NTD-NRC-94-4142
DCP/NRC0068
Docket No.: STN-52-003

SUBJECT: WESTINGHOUSE RESPONSES TO NRC REQUESTS FOR ADDITIONAL
INFORMATION ON THE AP600

NTD-NRC-94-4142
ATTACHMENT A
AP600 RAI RESPONSES
SUBMITTED MAY 19, 1994

FIGURE 2A-20

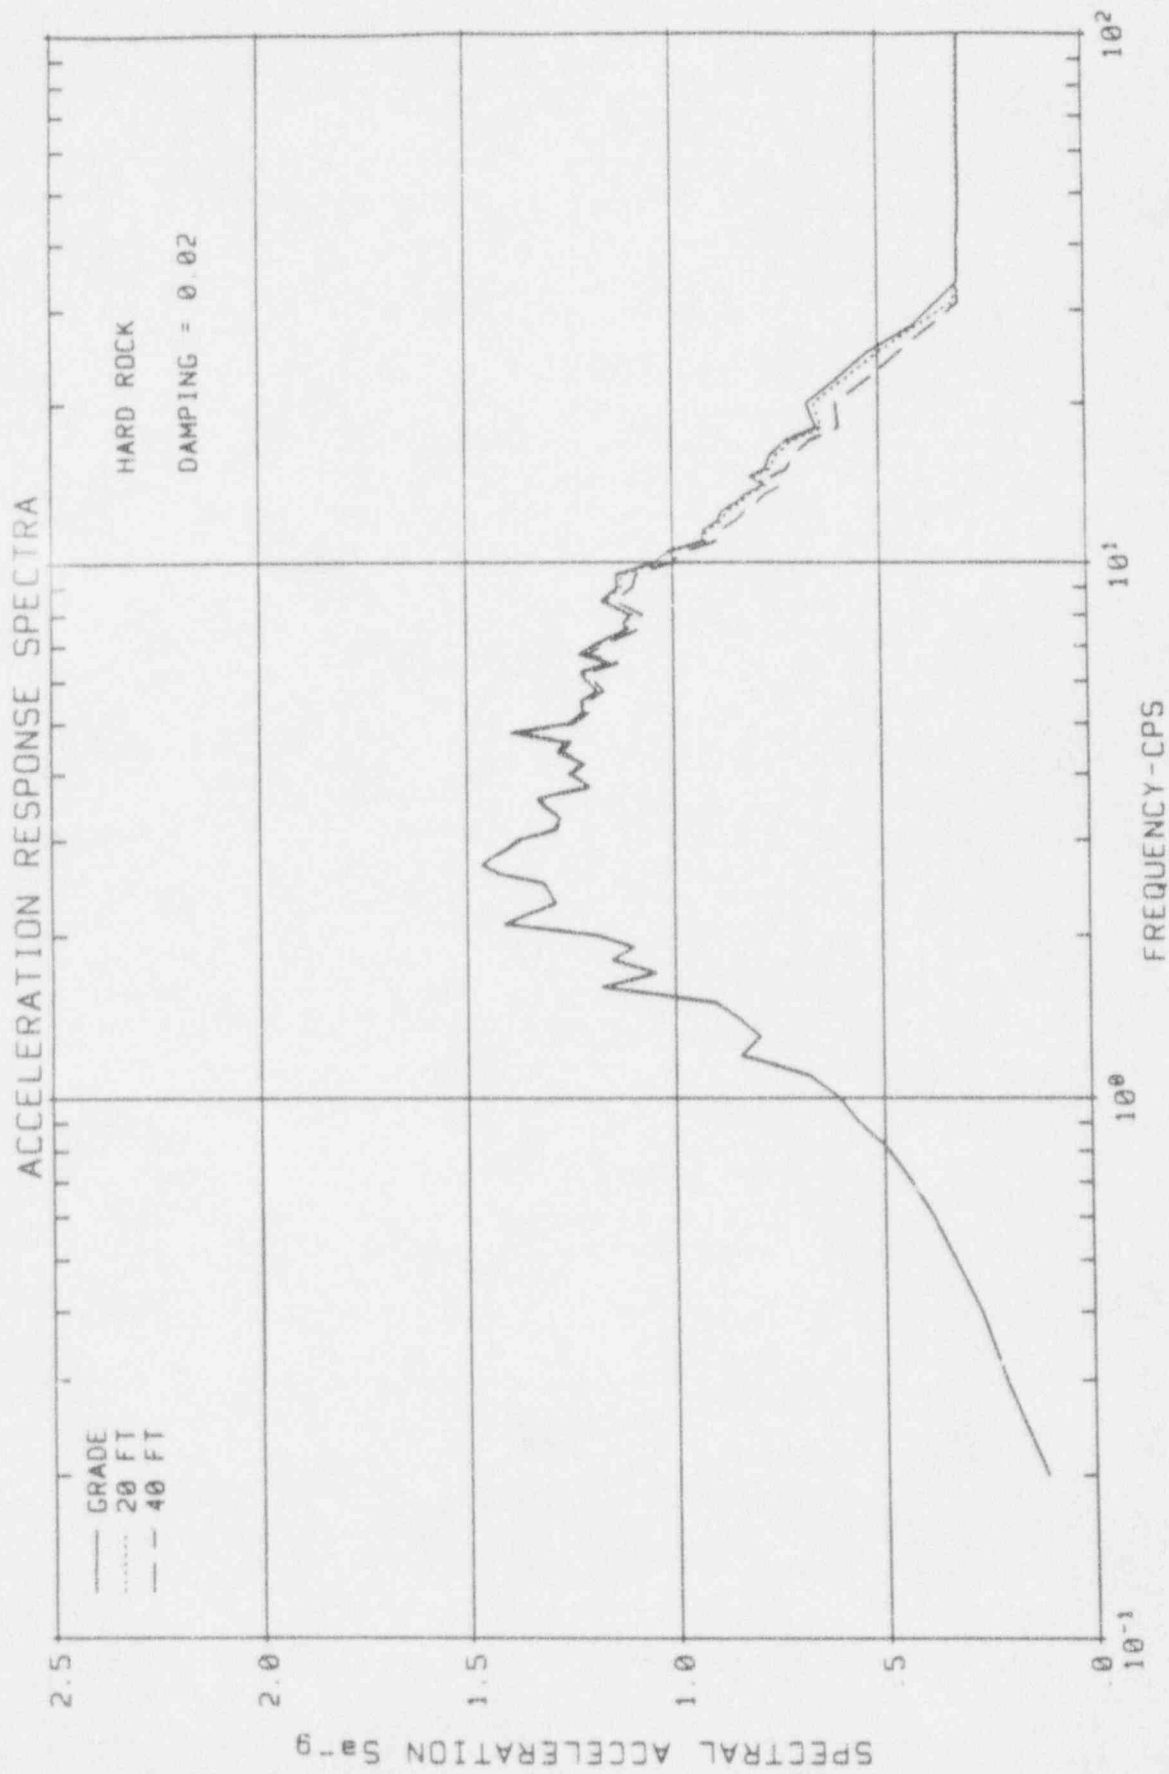
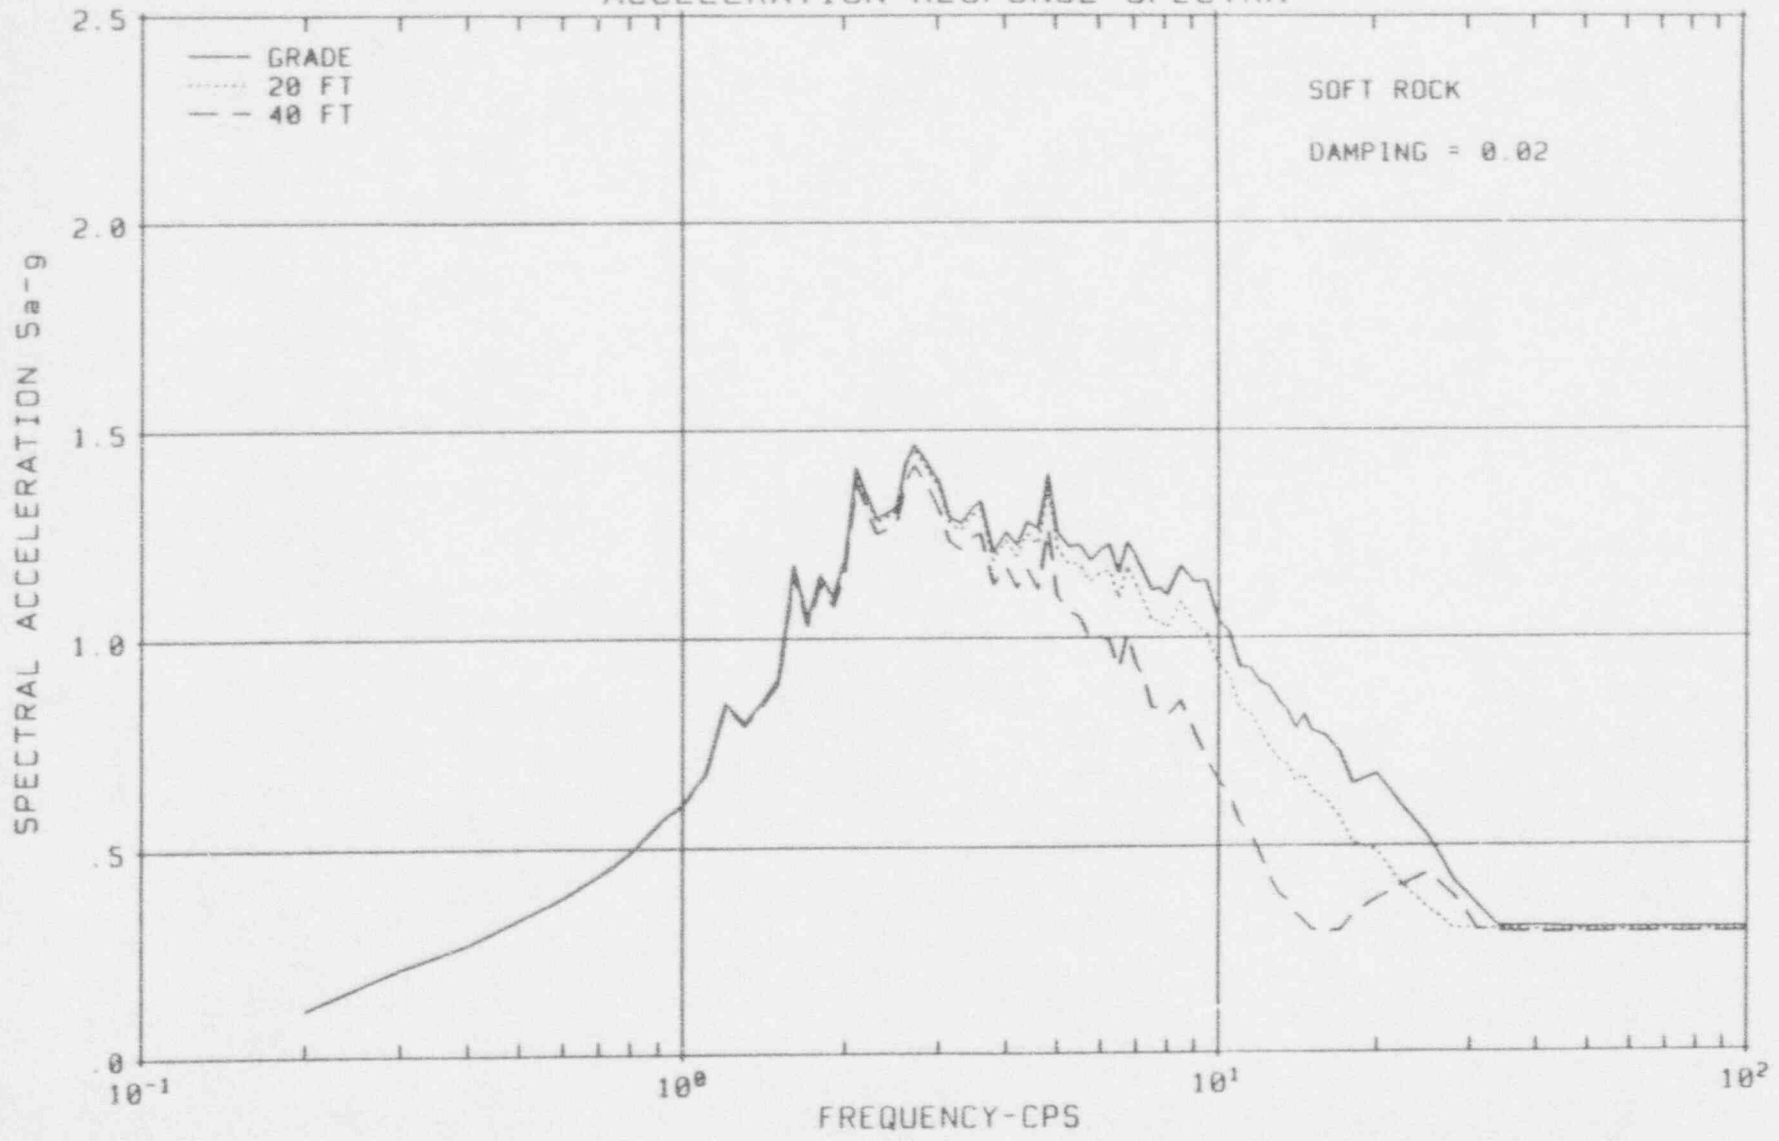
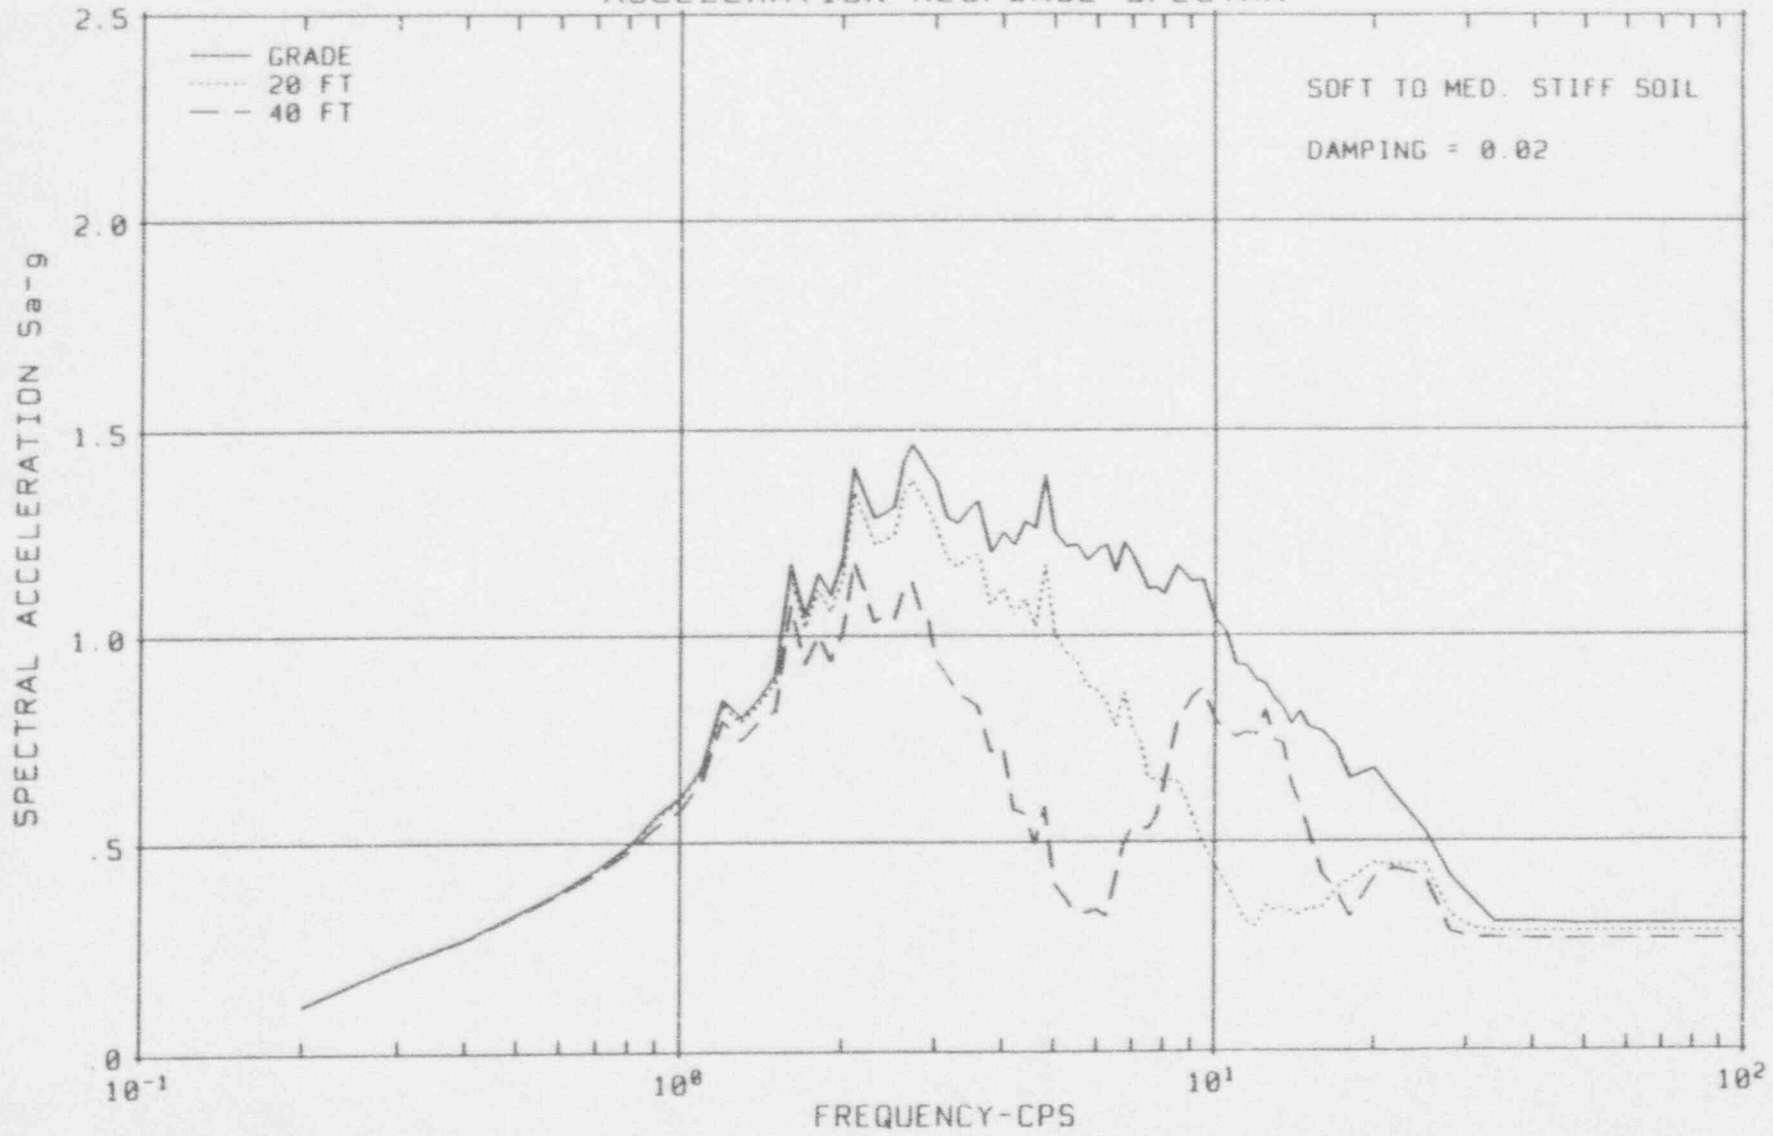
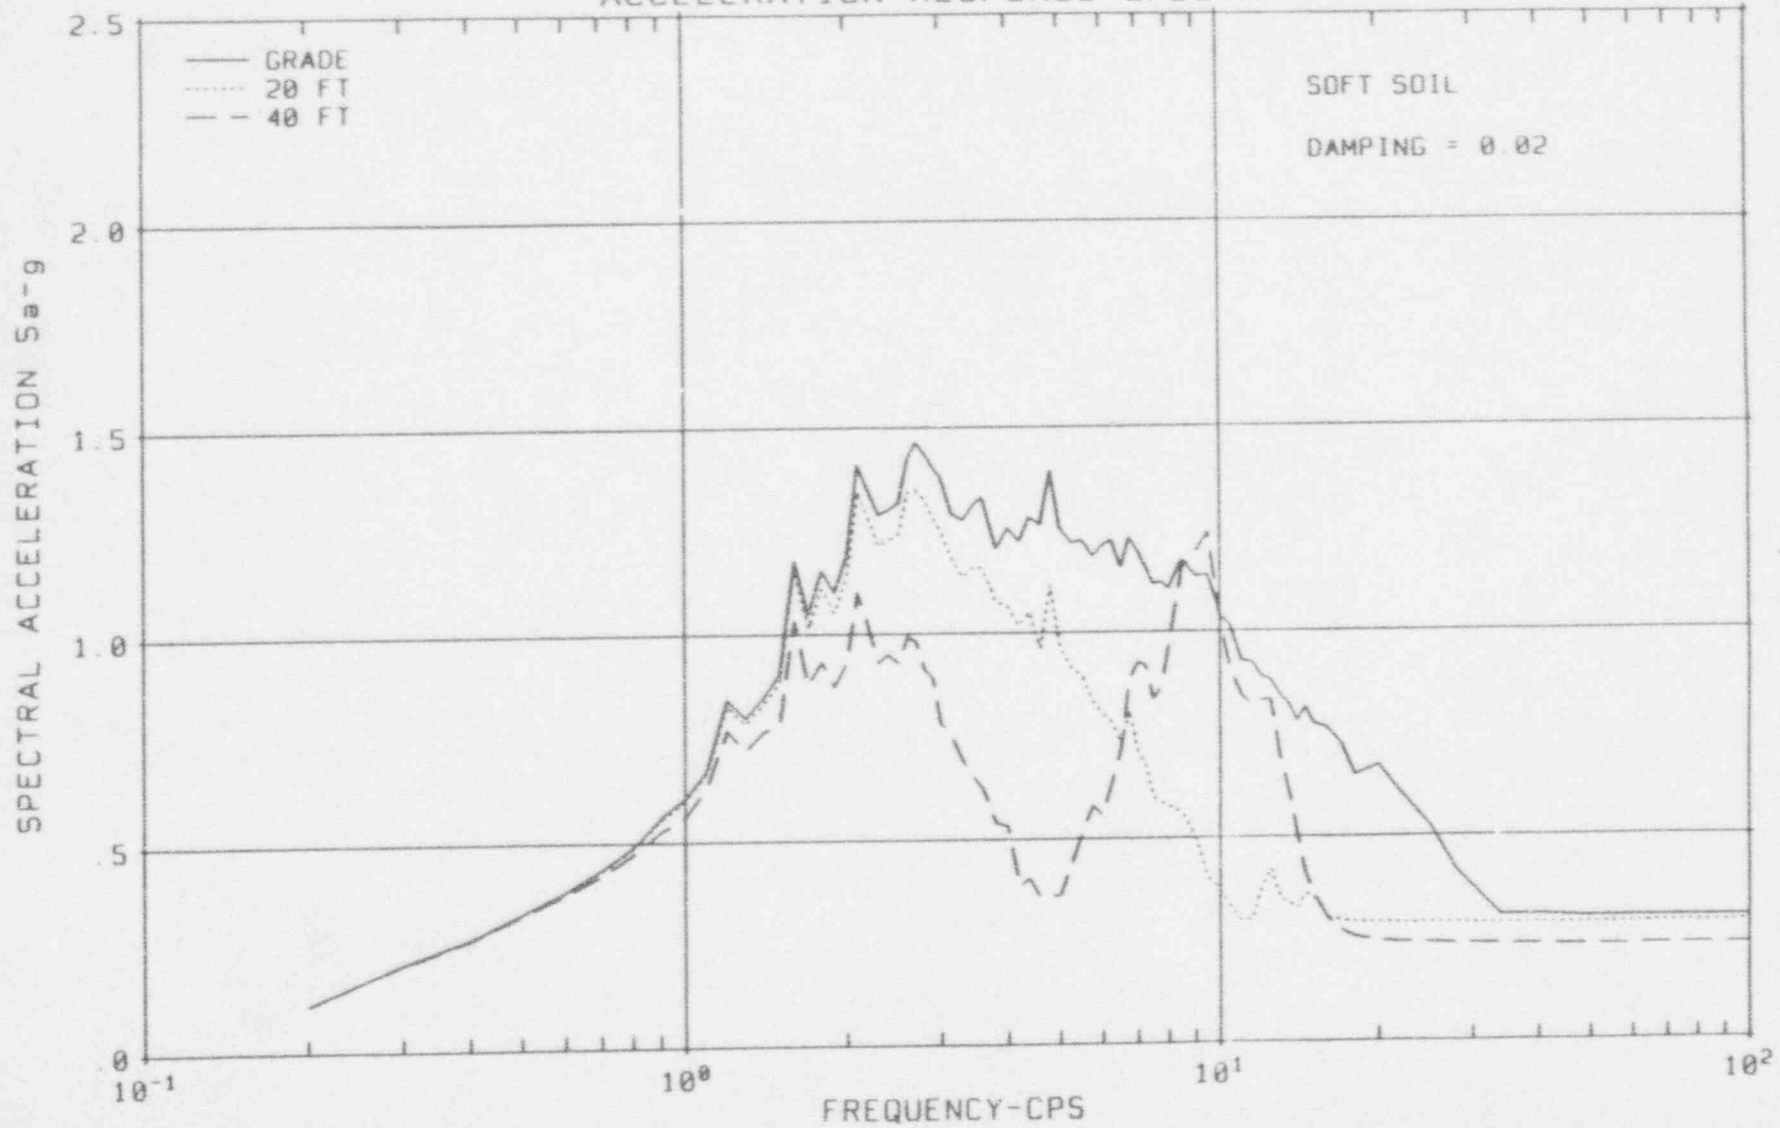
- a. In view of the above phenomenon, and referring to the response to Q231.10, justify not specifying the control motion at an actual or hypothetical rock outcrop in the above cases as well as other sites with one or more thin soil layers overlying rock.
- b. The response spectral curves in the above mentioned figures do not match the legends given in the figures. Clarify the figures.

- b. The response spectra plots were reviewed and match the legends. Attached are larger size plots of SSAR Figures 2A-20 through 2A-24 which may be easier to read.
